Company	Trenz Electronic GmbH
PCN Number	PCN-20201003
Title	TE0890-01 SPI Flash Change
Subject	BOM change
Issue Date	2020-10-06

This change affects all Trenz Electronic TE0890 modules of revision 01.

2.1 #1 Change SPI Flash from N25Q064A13ESE40F to IS25LP064D-JBLE

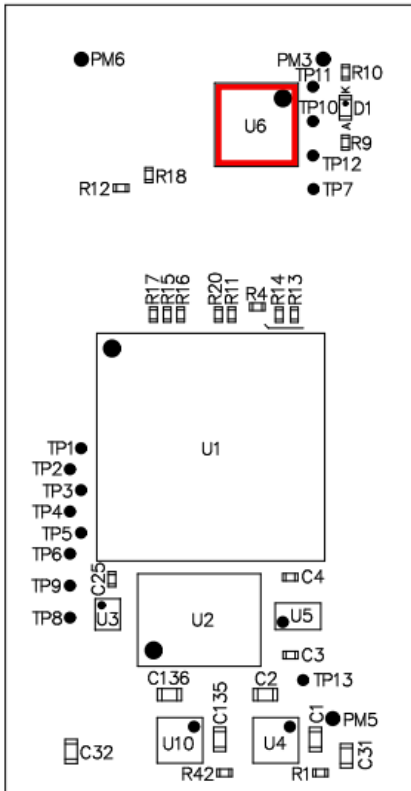
Type: BOM change

Reason: Old flash is obsolete.

Impact: JEDEC ID changes from BA17h to 6017h and manufacturer ID from 20h to 9Dh.

Locate Flash (U6) at top side of PCB:

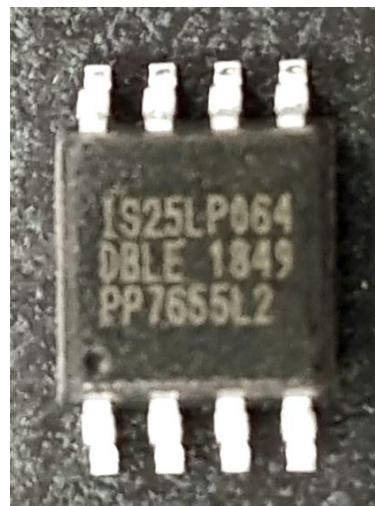
N25Q064A13ESE40F

IS25LP064D-JBLE
